AMENDED RECORD OF DECISION

**Accurate Die Casting Site
Village of Fayetteville, Onondaga County
Site Number 7-34-052**

October 1997

FIGURE 2

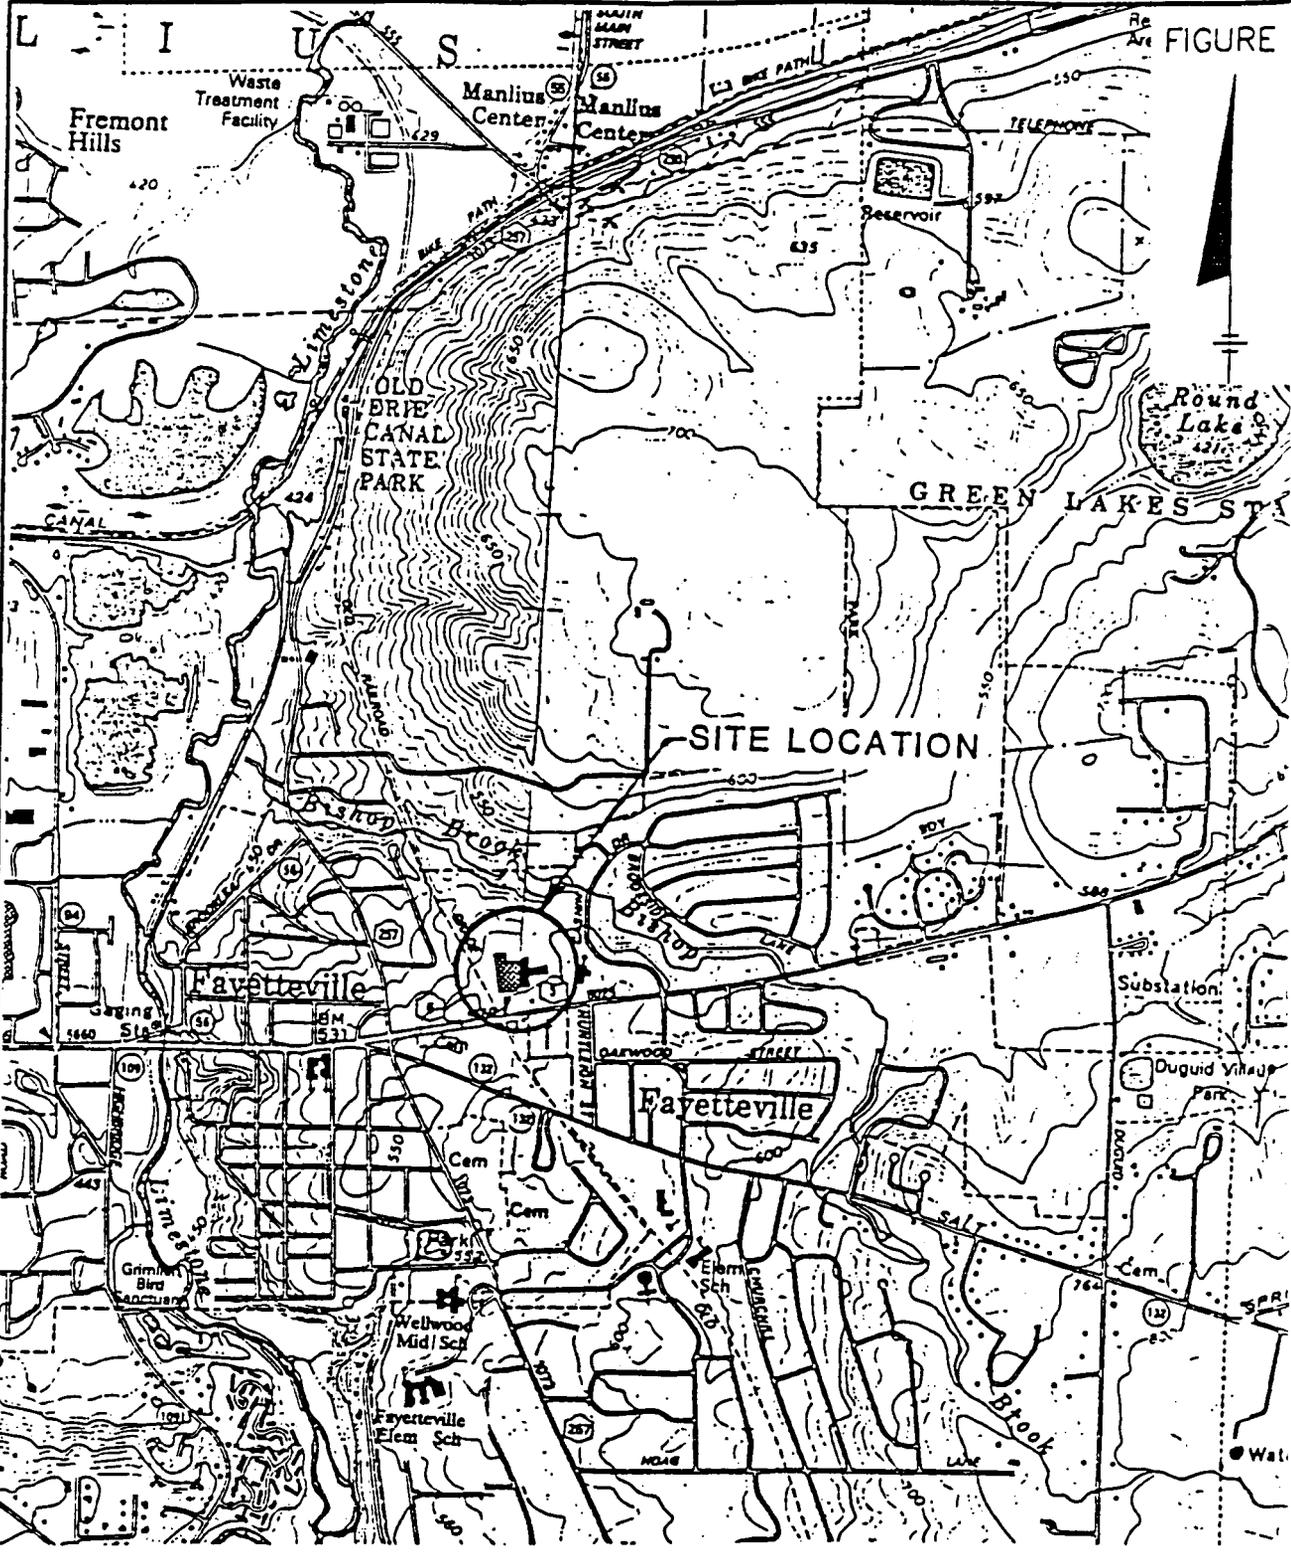
water sewer outlet, which exists in the northwest portion of the site, and east of the channel that extends from the outlet north toward the Bishop Brook. Figure 2 shows the area (CAMU) where the treated soil will be placed.

AREA 1:
PREVIOUSLY EXCAVATED PCB/PAH/VOC
SOILS AREA & LOCATION WHERE TREATED
SOILS WERE SPREAD ON SITE IN ACCORDANCE
WITH SEPTEMBER 1997 ROD AMENDMENT

FIGURE 3

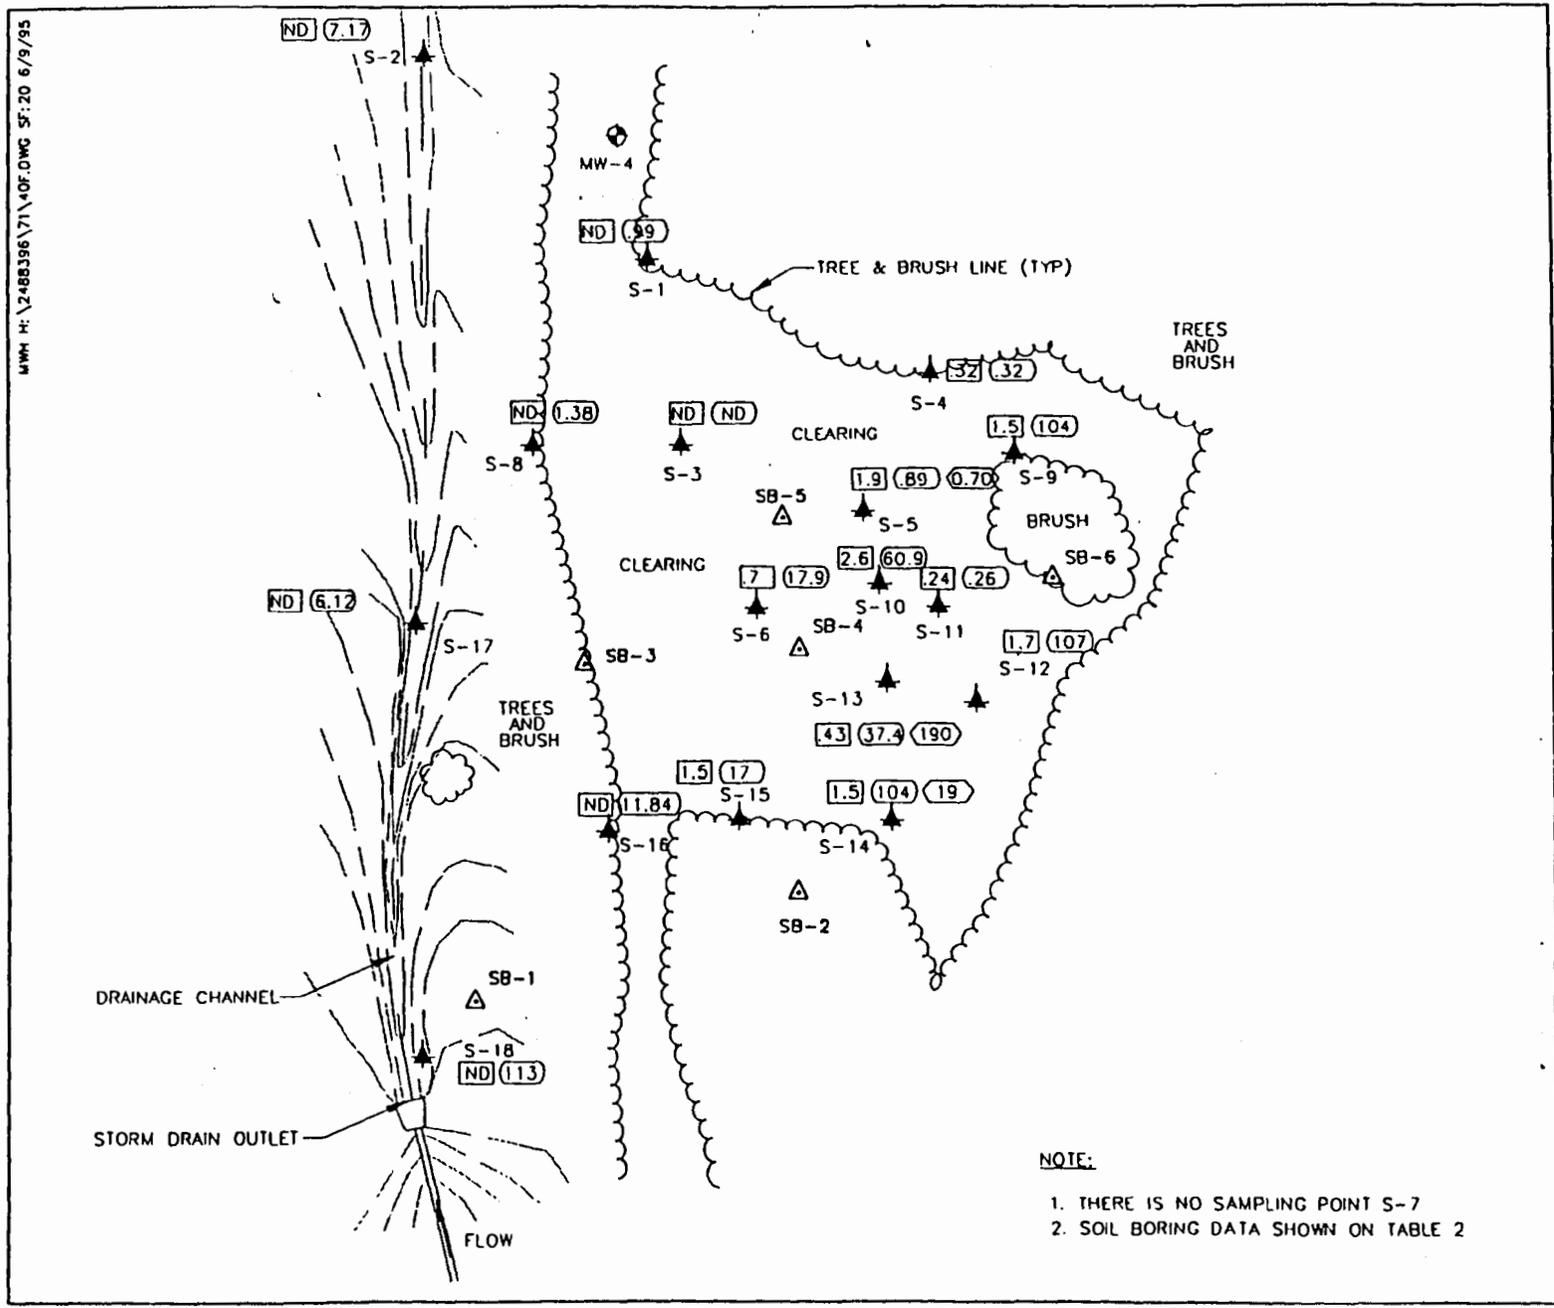
Several soil borings were installed during the remedial design at the PCB/VOC/PAH soils area to define the horizontal and vertical excavation limits. Figure 3 shows the locations of the soil borings installed during the pre-excavation soil sampling. The results (summarized in Table 3) showed that the contamination was more widespread in the surface and subsurface than was predicted during the investigation. PCBs, PAHs and VOCs, particularly TCE and 1,2-DCE were detected above established background levels at several sampling locations. An area significantly contaminated with TCE was identified at the center of this area. Based on the results of this sampling event, the vertical extent of excavation was increased when compared to the estimated depth of excavation in the ROD.
